The Millbrook Power (Gas Fired Power Station) Order

5.2 Consultation Report Appendices – Volume 5 Appendices 5.A – 5.G

Consultation Report Appendices Volume 5 index

ISSUE NO.	COMMENTS	DATE	AUTH.
REVISION DETAILS			
Drawing Title:			
Millbrook Power Station Proposed Redline Boundaries with Affected Water Assets

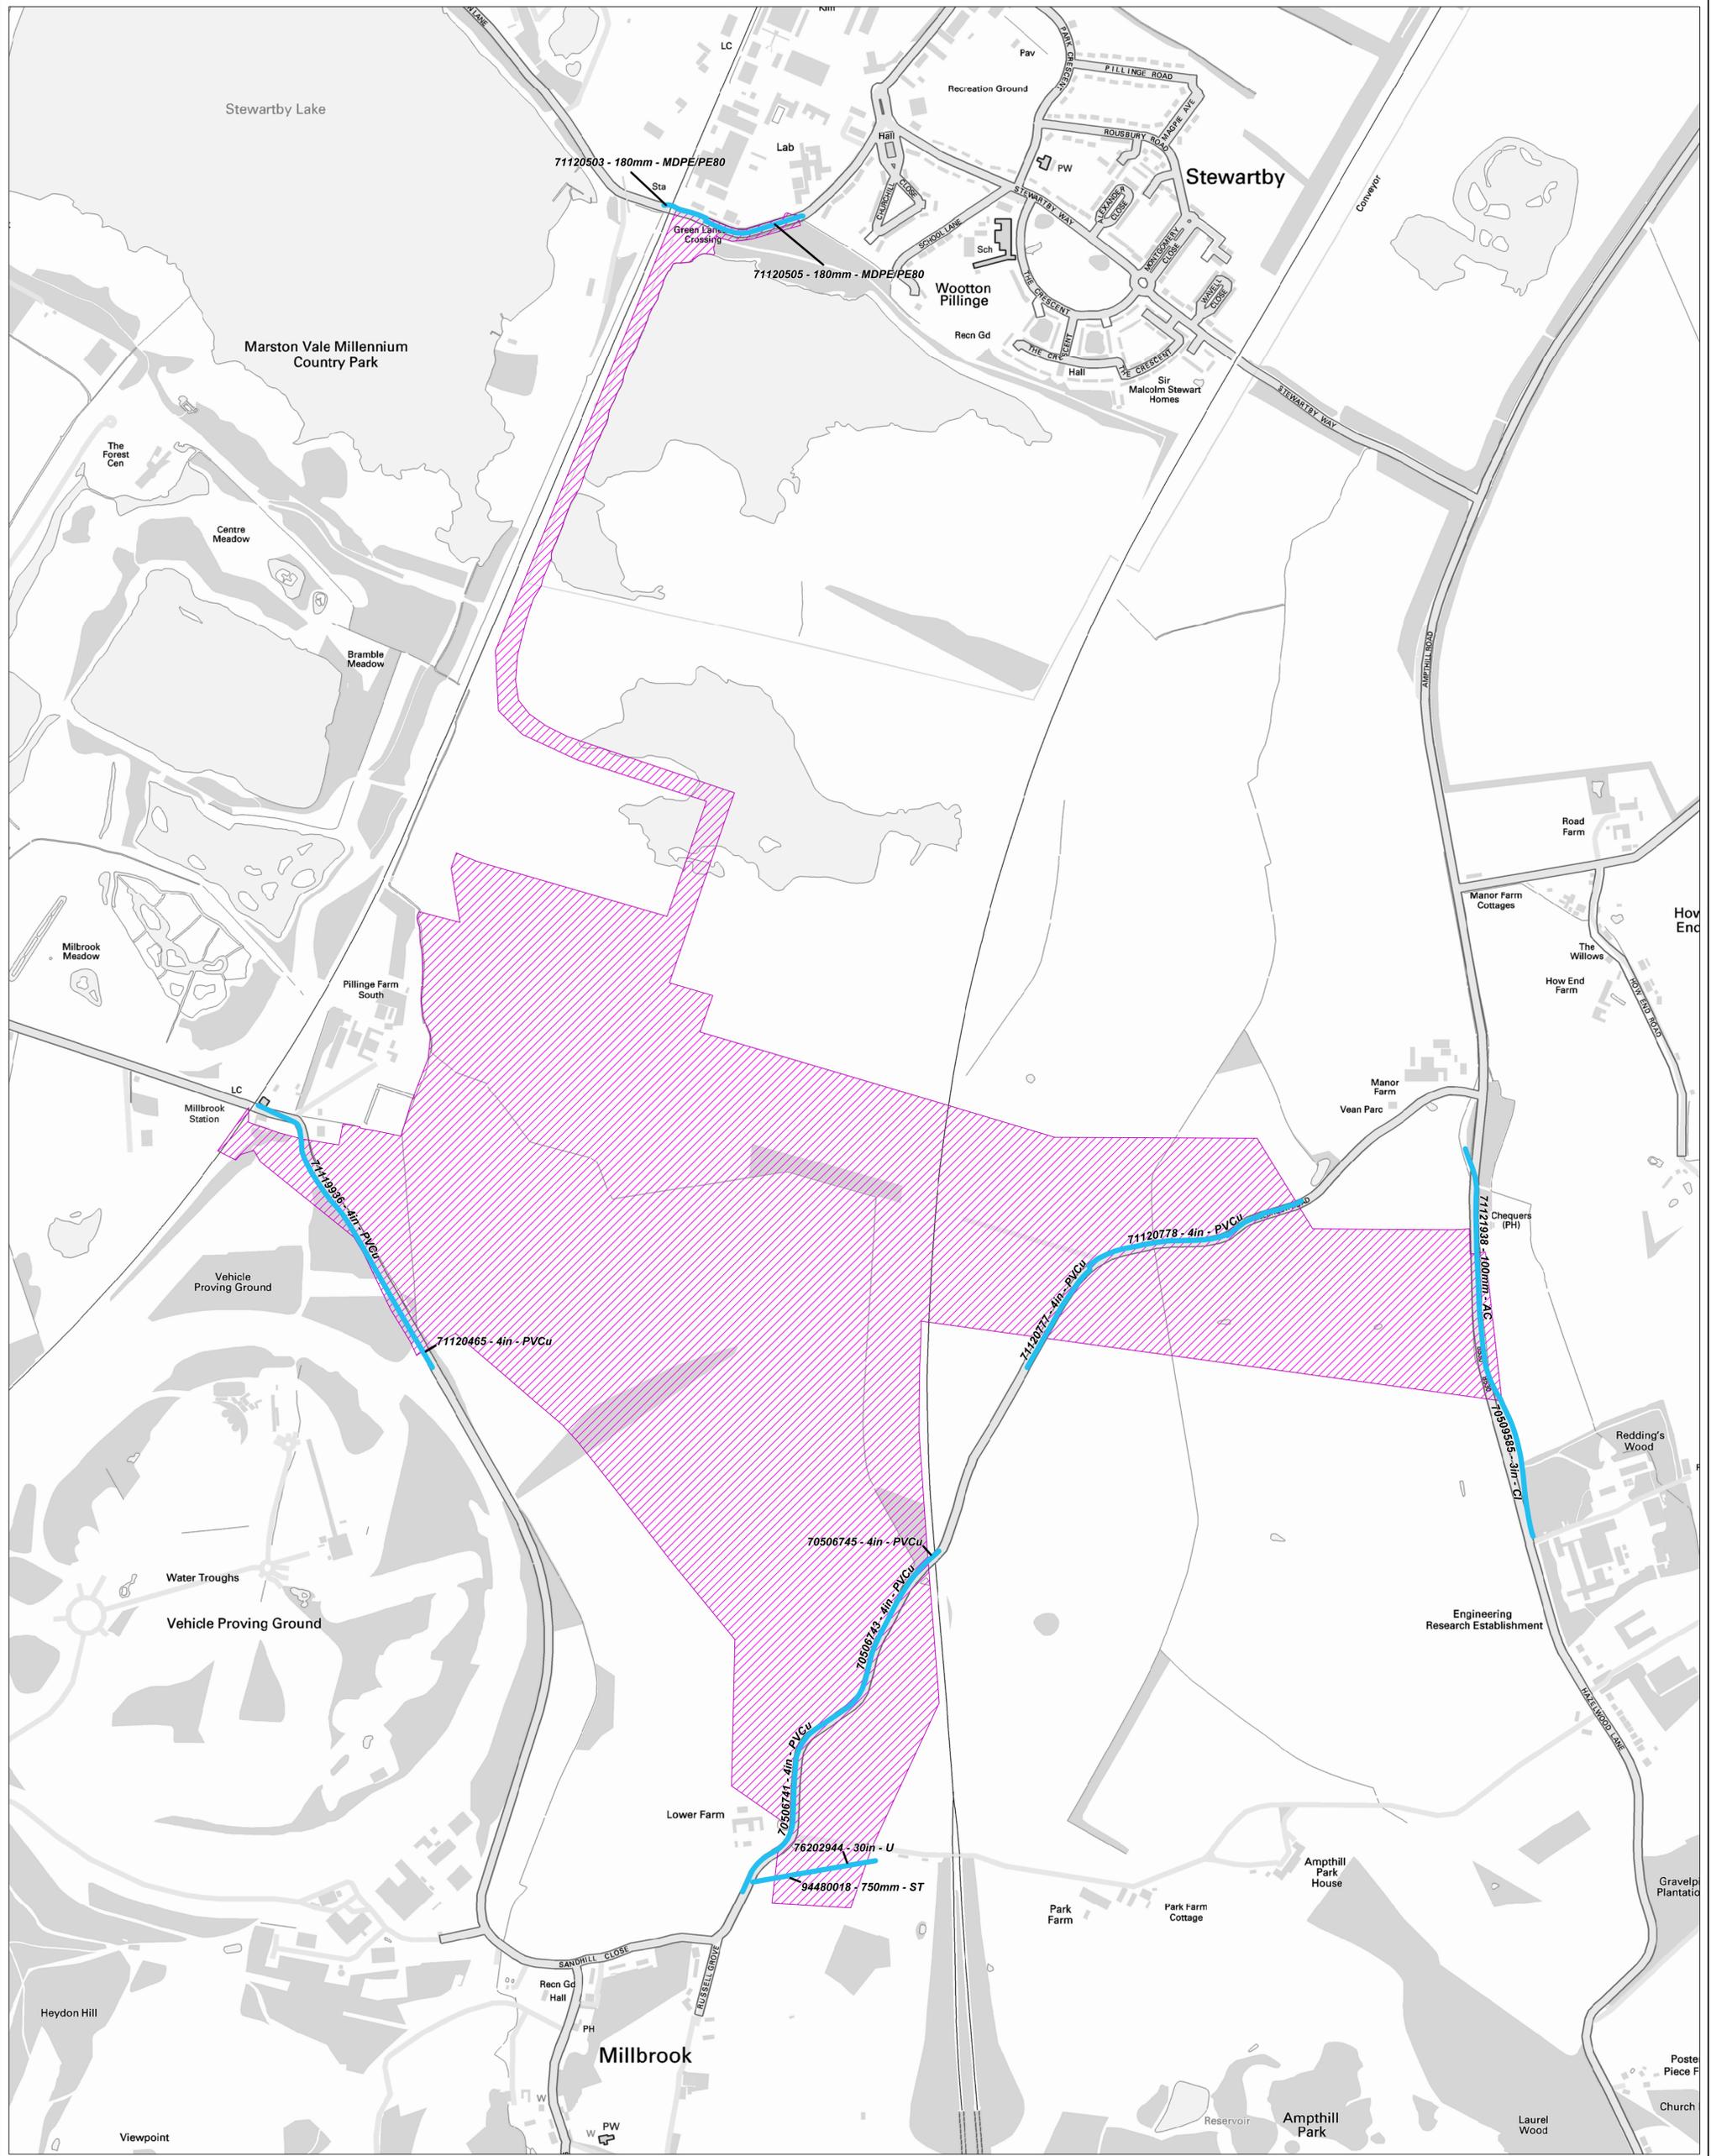
Our records show that there are water mains or other assets owned by this company within the proposed Power Plant and temporary construction areas. In relation to these assets, having laid the asset under statutory notice, Anglian Water would require the standard protected easement widths for these assets and for any requests for alteration or removal to be conducted in accordance with the Water Industry Act 1991 and Protective Provisions will be sought by Anglian Water.

Plans indicating the assets affected by the Power Plant are attached together with a schedule indicating the assets affected.
